# Architect's Supplemental Instructions

Police Department Midtown District

ASI Number 004

1/25/2018

**ROOF FRAMING  
PLAN**

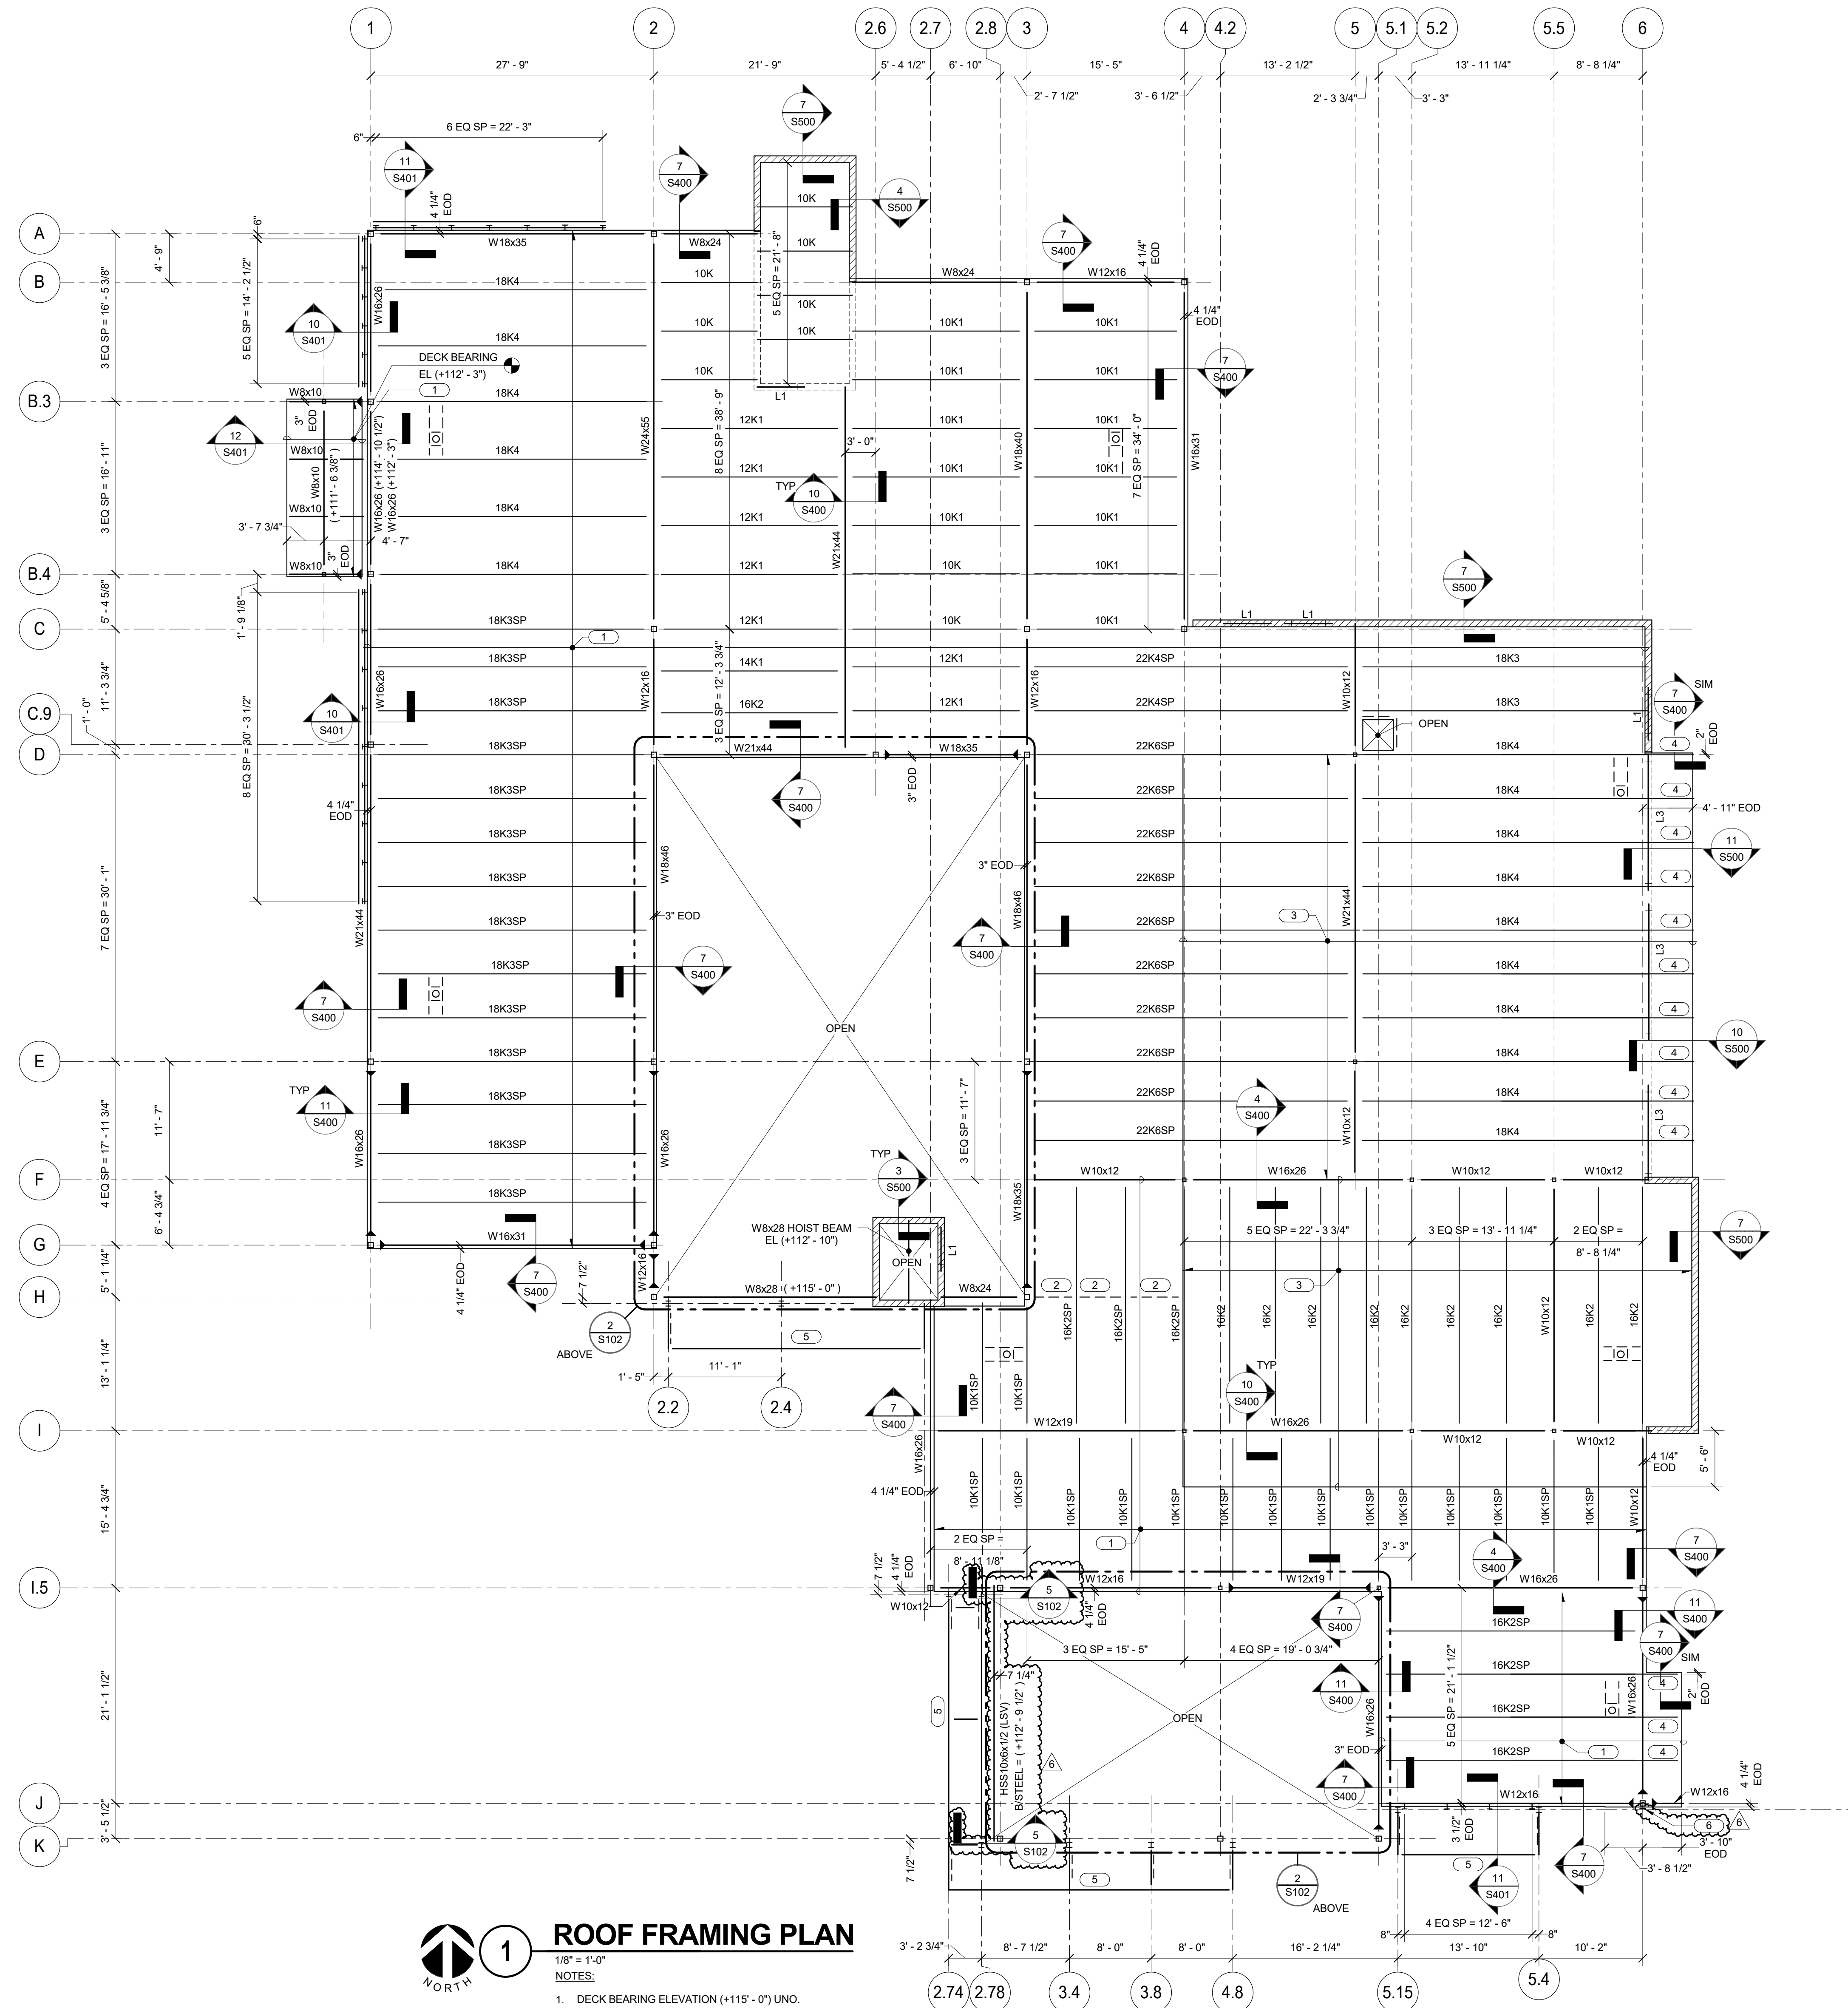
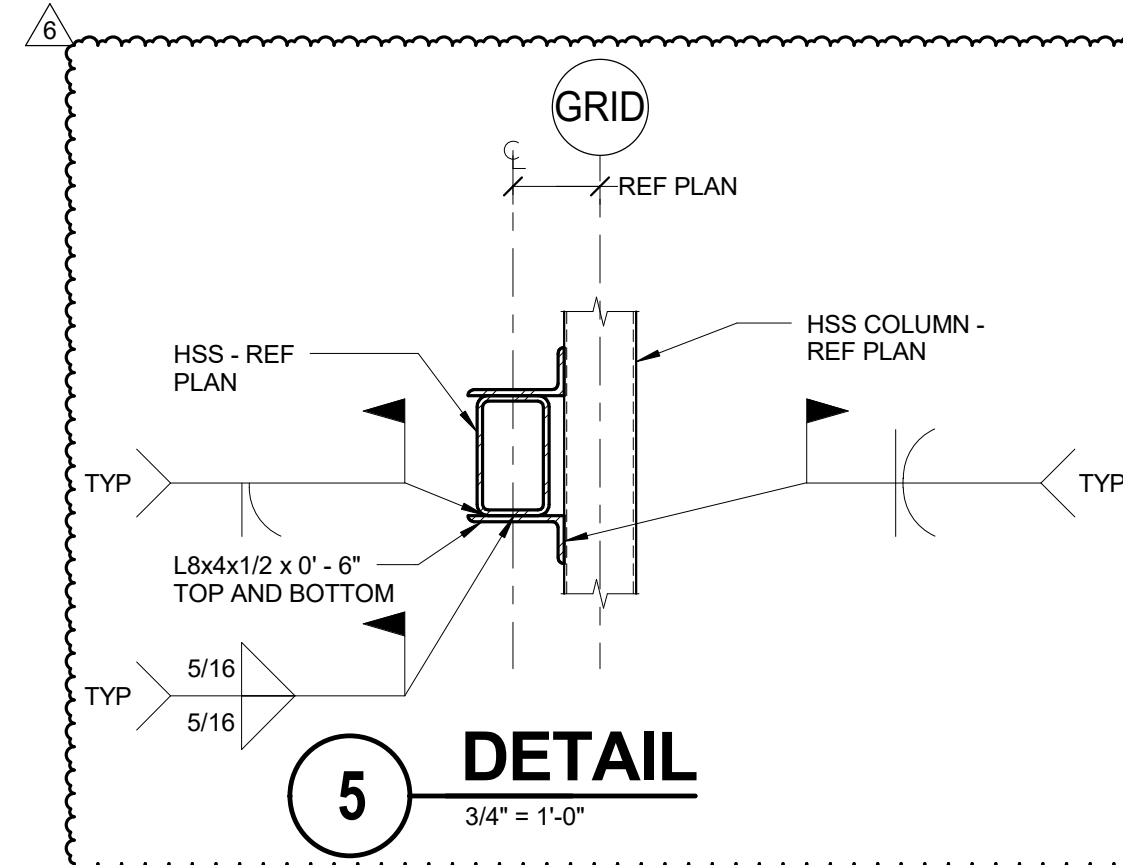
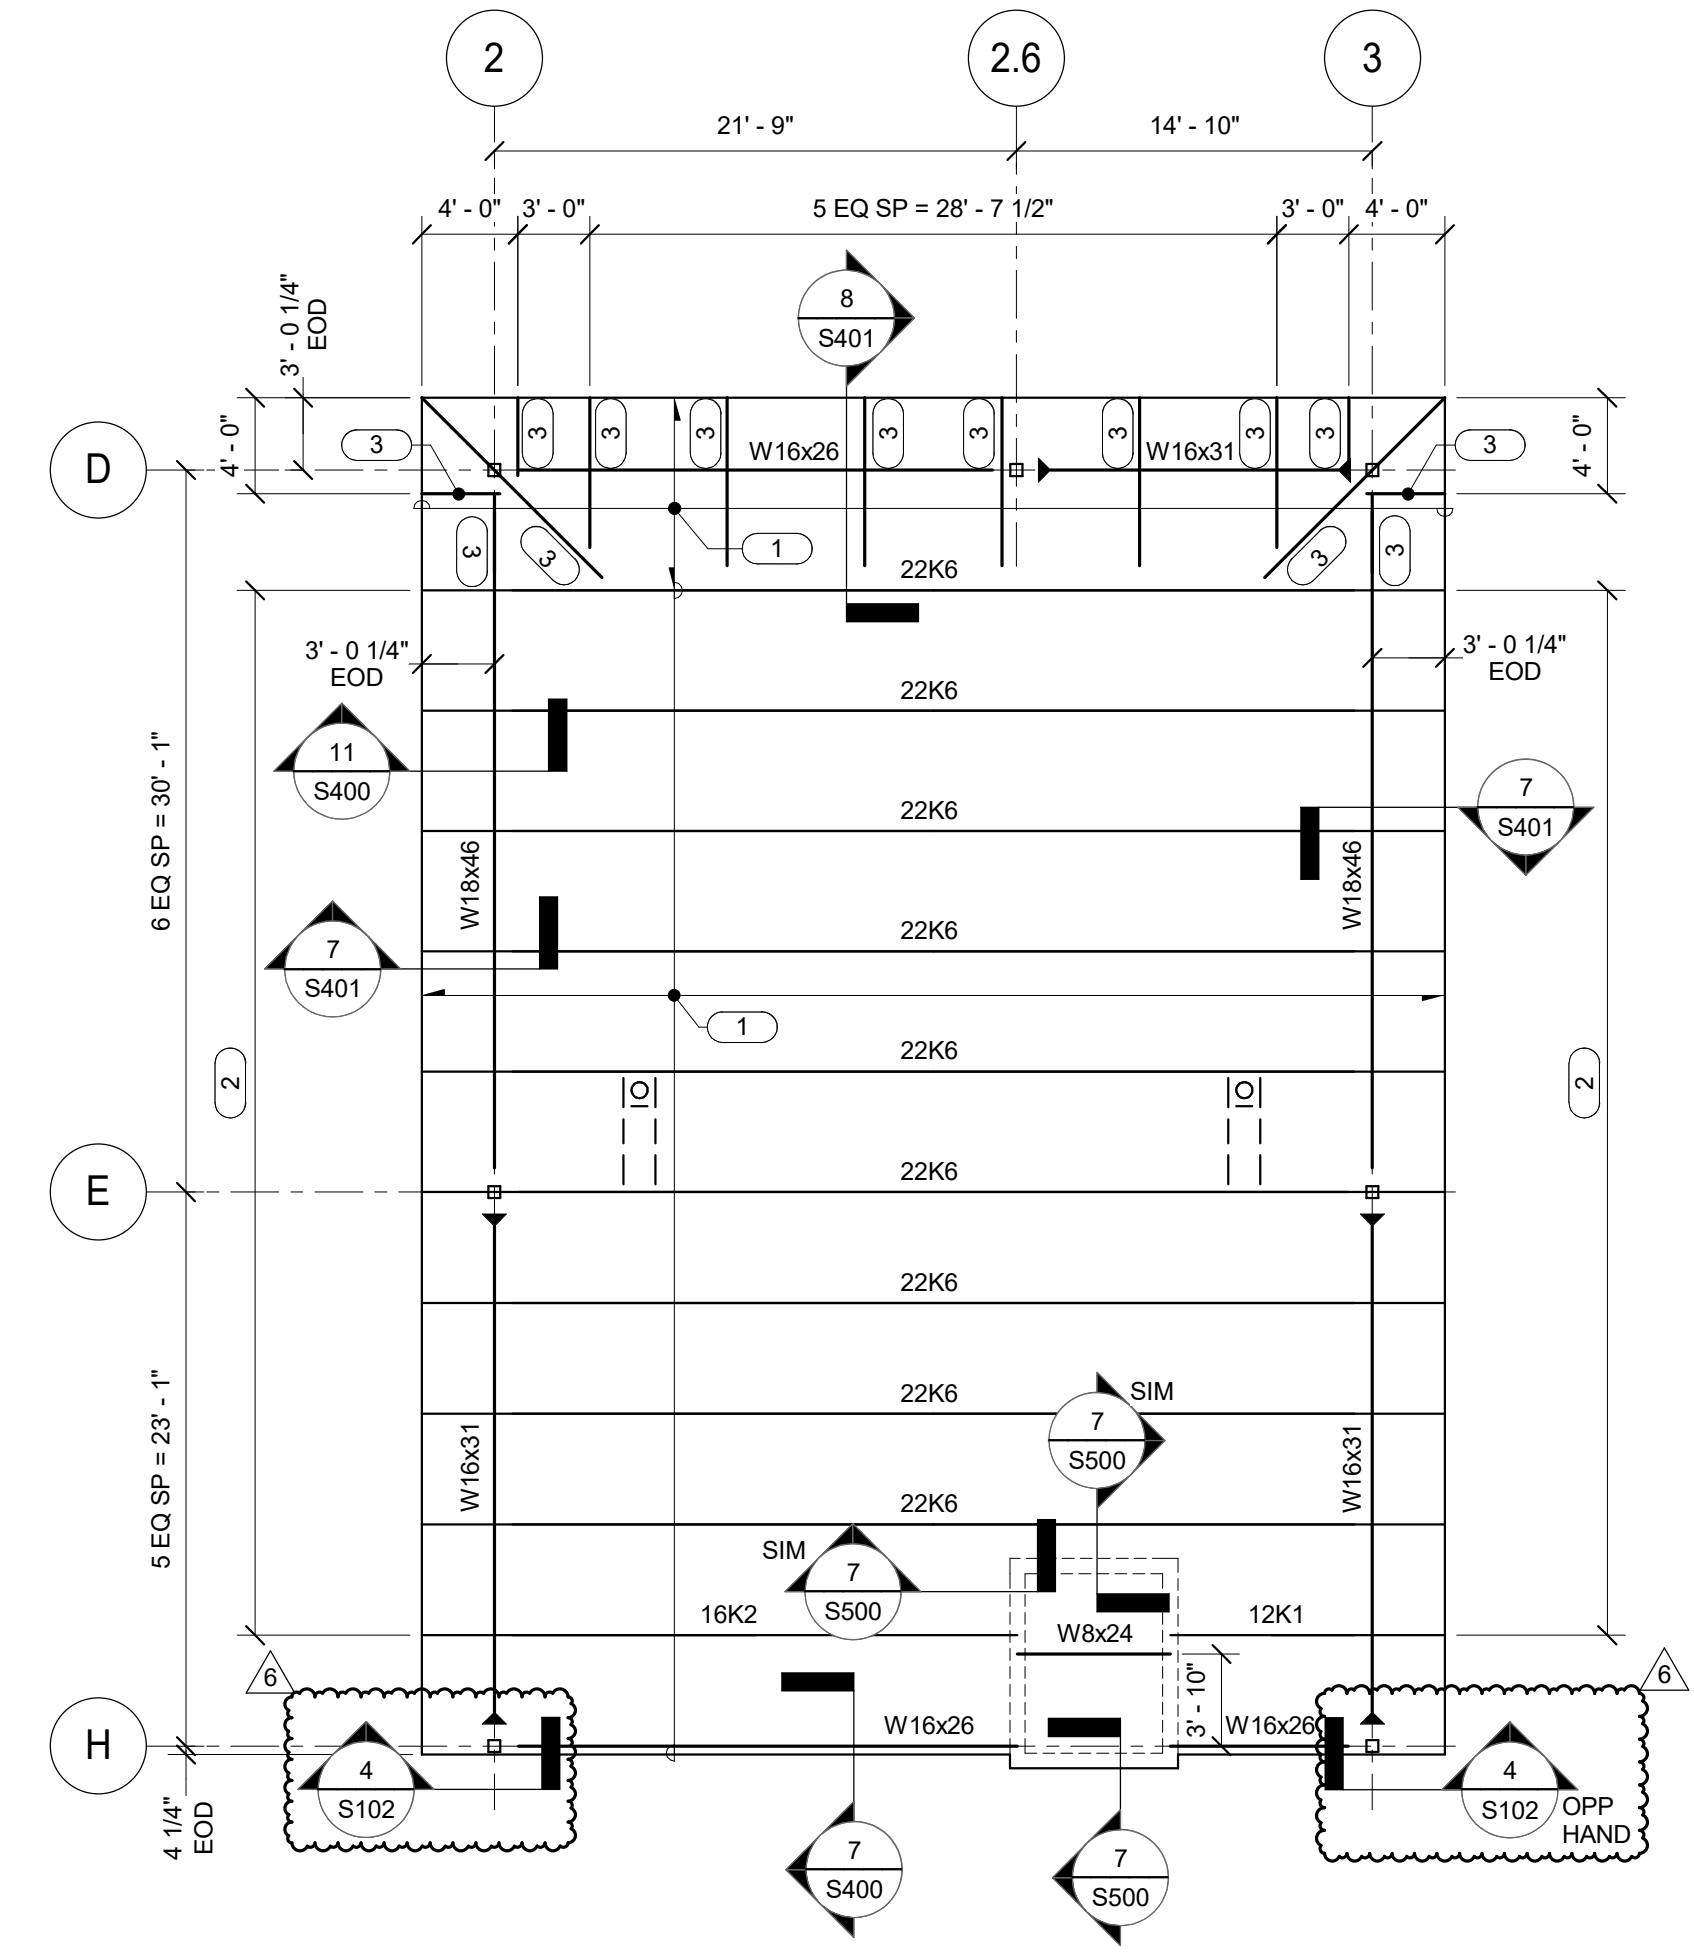
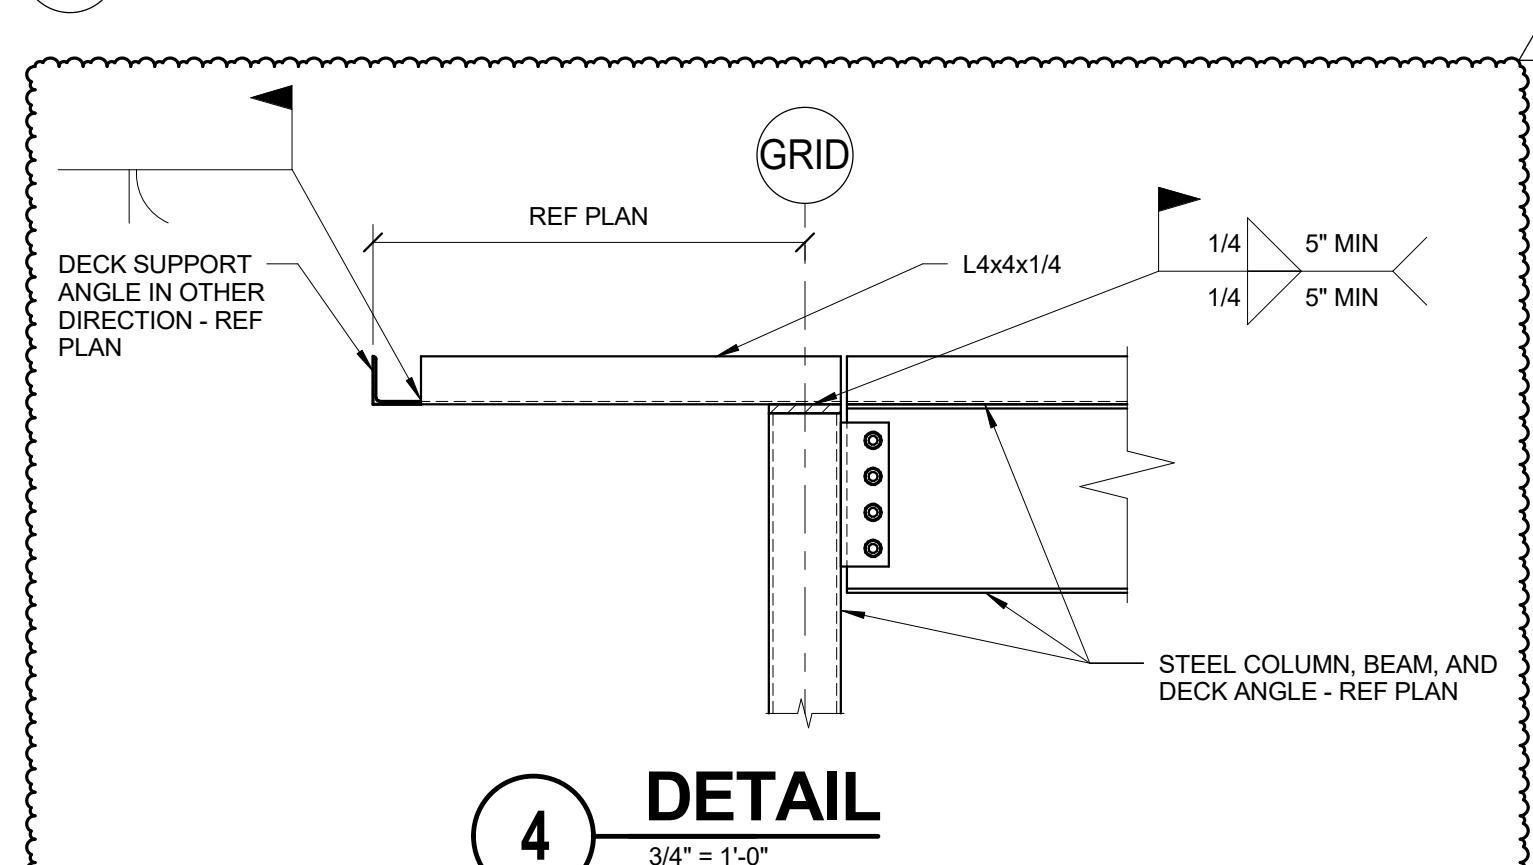
5. The attached sheet S102 has been issued with the following revisions:
  - A. Detail 2/S102 ADD deck support angle to clerestory framing along Grid H - refer to detail 4
  - B. Detail 1/S102 ADD angle to steel column to support light gage header at Column J-6 as addressed in RFI 020.
  - C. Detail 1/S102 ADD HSS 10x6 structural header over Storefront M attached to building columns for support of stud wall above as addressed in RFI 020

KEYNOTE 4: L6x3 1/2x5/16 x 0'-8" ANGLE FIELD WELDED WITH 1/4" FILLET WELDS TOP AND BOTTOM TO SOUTH FACE (OR EAST FACE AT CONTRACTOR'S OPTION) OF COLUMN TO SUPPORT LIGHT GAGE HEADER. COORDINATE ELEVATION WITH LIGHT STUD CONTRACTOR.
